SUBSURFACE WASTEWATER DISPOSAL SYSTEM APPLICATION

PROPERTY LOCATION		>> Caution: Permit Required – Attach in Space Below <<	
City, Town, or Plantation	Augusta		
Street or Road	6 Church Hill Road		
Subdivision, Lot #

REPLACEMENT SYSTEM VARIANCE REQUEST

Subject: Approval, Replacement System Variance Request, Farr Property, 6 Church Hill Road, Augusta

SUBSURFACE WASTEWATER DISPOSAL PLAN

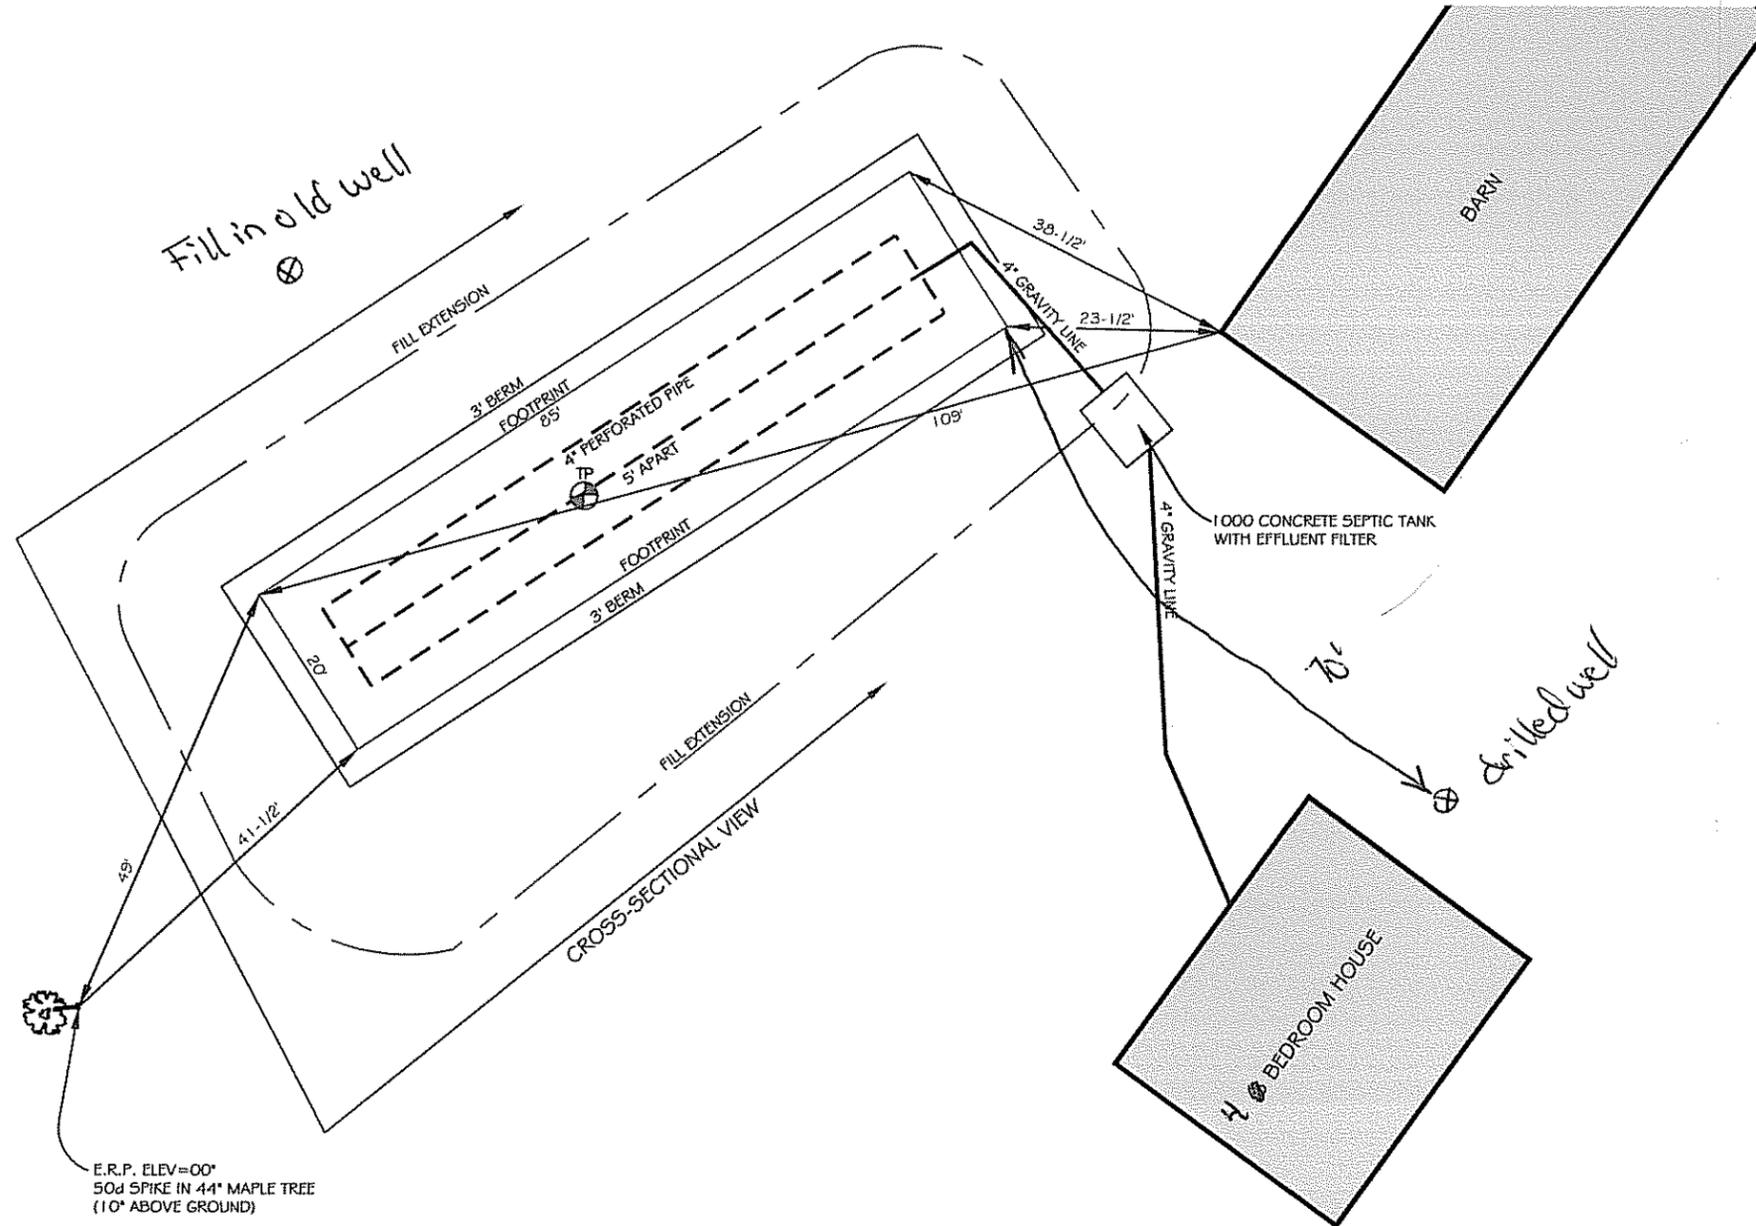
The Division has reviewed a Replacement System Variance Request for the subject property. The proposal is to install a replacement septic system to serve a four-bedroom single-family dwelling. The state variances requested are to allow the installation of the system with a setback distance reduction from the owner's well to the disposal field of 70 feet, and to the septic tank of 50 feet. The system design, prepared by Kane Coffin, SE, dated April 29, 2004 is found to be in compliance with the Maine Subsurface Wastewater Disposal Rules.

We approve the requested variances with the following requirements:

1. A permit for system installation shall be obtained from the Local Plumbing Inspector in advance of the start of system construction.
2. The system shall be installed in accordance with the submitted and approved system design. Should alterations be required at the time of system installation, the system designer must be notified prior to making any changes.
3. The variance approval is based only on the rules administered by this department. The approval of the variance request does not relieve the property owner from compliance with all other state and local requirements pertaining to the installation, use, and operation of the wastewater disposal system.
